**PUBLIC INTEREST REVIEW FOR GROUND WATER APPLICATIONS**

TO: Water Rights Section Date 11 July 2012  
 FROM: Ground Water/Hydrology Section Gerald H. Grondin  
Reviewer's Name  
 SUBJECT: Application G-16904 Supersedes review of 11 March 2008  
Date of Review(s)

**A. GENERAL INFORMATION:** Applicant's Name: Valley Falls Ranch, Inc. County: Lake

Proposed Well 1 to Crooked Creek

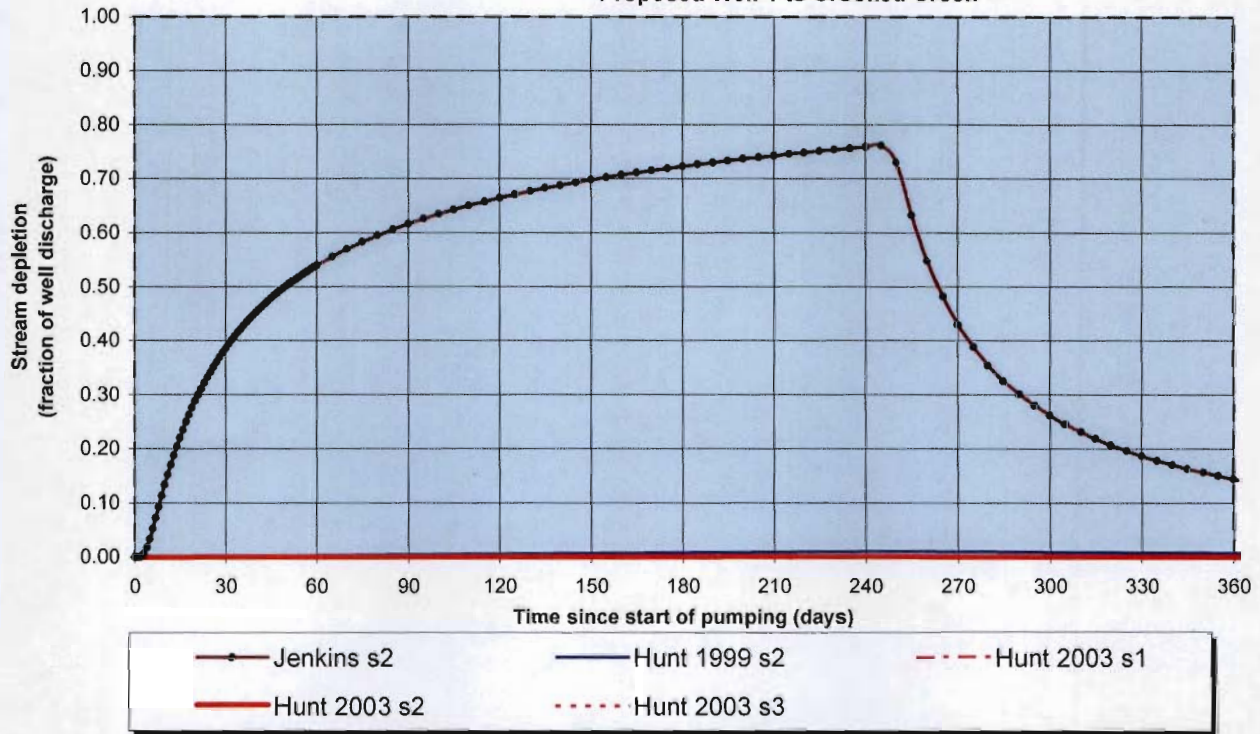
The proposed well location is more than 1.0 mile from Crooked Creek.

Hunt (2003) was used to calculate the interference given the recommended condition that the wells obtain groundwater from the predominantly basalt unit below the predominantly basin fill sediment unit. The calculations used a horizontal hydraulic conductivity of 30 feet/day (transmissivity = 15,000 ft<sup>2</sup>/day which is consistent with Morgan (1988) and McFarland and Rvals (1991)), a vertical conductivity of 0.3 feet/day, 0.01 for the storage coefficient, and a basin-fill sediment thickness of 350 feet at the stream (based on LAKE 52274). The stream width used for the calculation (25 feet) is maybe greater than the actual stream width. A smaller stream width would result in a smaller calculated interference.

When obtaining groundwater from the predominant basalt unit, the calculated interference with the creek for each month remains less than 1.00 percent of the natural stream flow (80 percent exceedance). It should be noted that pumping groundwater from the predominantly basin-fill unit would likely result in interference with the creek that exceeds the 1.00 percent of the natural stream flow (80 percent exceedance) during some months. That is a major reason why groundwater needs to be obtained from the predominantly basalt unit only.

**Transient Stream Depletion (Jenkins, 1970; Hunt, 1999, 2003)**  
**Proposed Well 1 to Willow Creek**

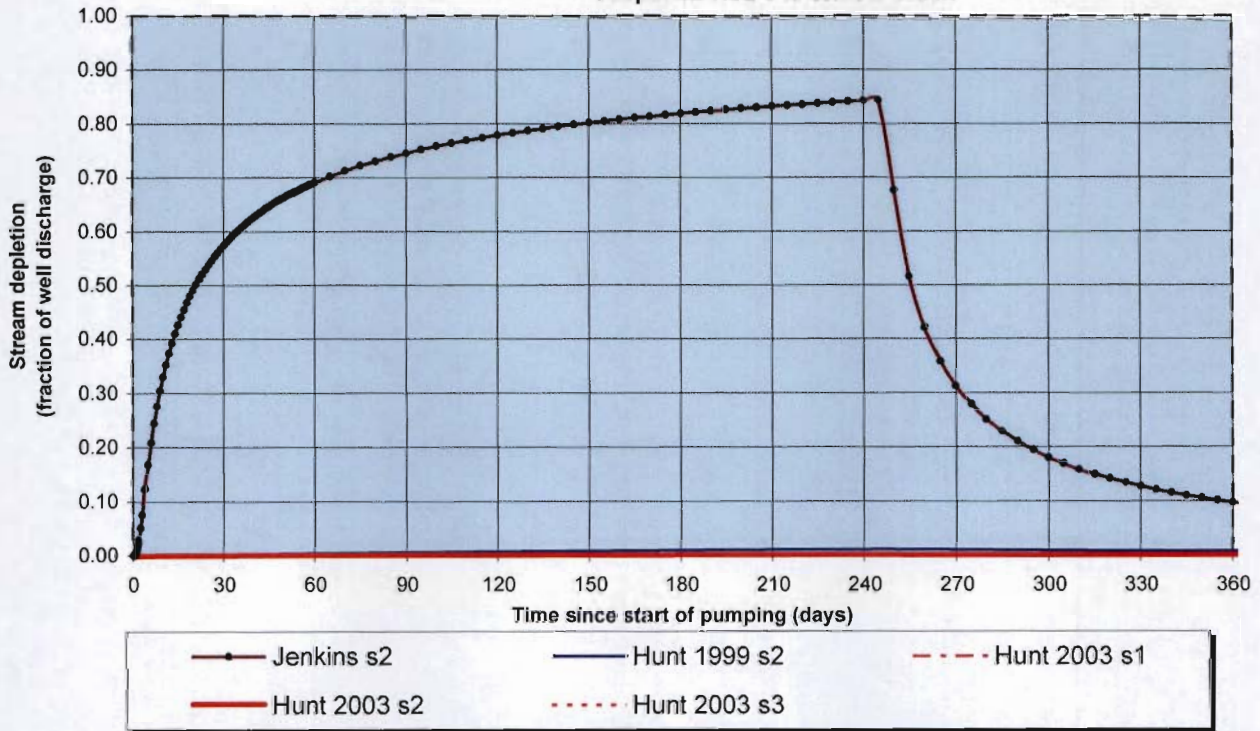
The proposed well location is more than 1.0 mile from Willow Creek.

Hunt (2003) was used to calculate the interference given the recommended condition that the wells obtain groundwater from the predominantly basalt unit below the predominantly basin fill sediment unit. The calculations used a horizontal hydraulic conductivity of 30 feet/day (transmissivity = 15,000 ft<sup>2</sup>/day which is consistent with Morgan (1988) and McFarland and Ryals (1991)), a vertical conductivity of 0.3 feet/day, 0.01 for the storage coefficient, and a basin-fill sediment thickness of 350 feet at the stream (based on LAKE 52274). The stream width used for the calculation (25 feet) is may be greater than the actual stream width. A smaller stream width would result in a smaller calculated interference.

When obtaining groundwater from the predominant basalt unit, the calculated interference with the creek for each month remains less than 1.00 percent of the natural stream flow (80 percent exceedance). It should be noted that pumping groundwater from the predominantly basin-fill unit would likely result in interference with the creek that exceeds the 1.00 percent of the natural stream flow (80 percent exceedance) during some months. That is a major reason why groundwater needs to be obtained from the predominantly basalt unit only.

**Transient Stream Depletion (Jenkins, 1970; Hunt, 1999, 2003)**  
**Proposed Well 1 to Chewaucan River**

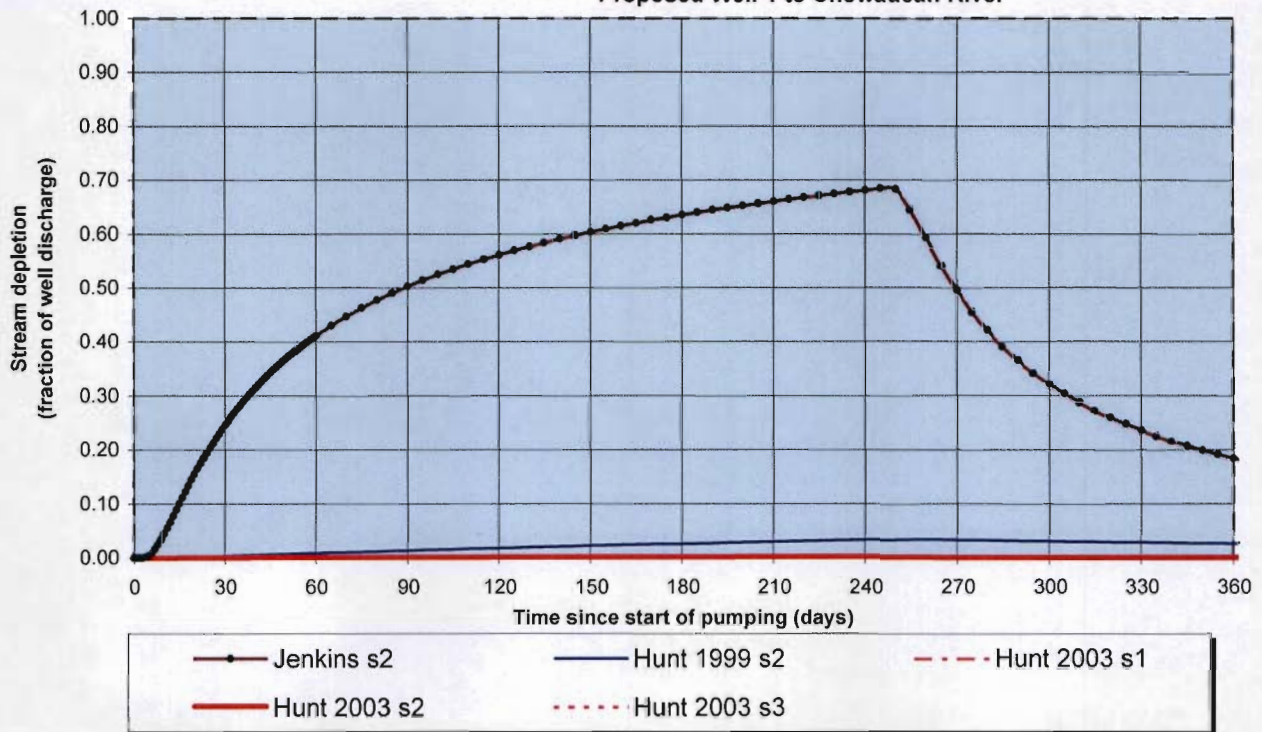
The proposed well location is more than 1.0 mile from Chewaucan River.

Hunt (2003) was used to calculate the interference given the recommended condition that the wells obtain groundwater from the predominantly basalt unit below the predominantly basin fill sediment unit. The calculations used a horizontal hydraulic conductivity of 30 feet/day (transmissivity = 15,000 ft<sup>2</sup>/day which is consistent with Morgan (1988) and McFarland and Ryals (1991)), a vertical conductivity of 0.3 feet/day, 0.01 for the storage coefficient, and a basin-fill sediment thickness of 350 feet at the stream (based on LAKE 52274). The stream width used for the calculation (100 feet) is approximate to the actual stream width. A smaller stream width would result in a smaller calculated interference.

When obtaining groundwater from the predominant basalt unit, the calculated interference with the river for each month remains less than 1.00 percent of the natural stream flow (80 percent exceedance). It should be noted that pumping groundwater from the predominantly basin-fill unit would likely result in interference with the river that exceeds the 1.00 percent of the natural stream flow (80 percent exceedance) during some months. That is a major reason why groundwater needs to be obtained from the predominantly basalt unit only.
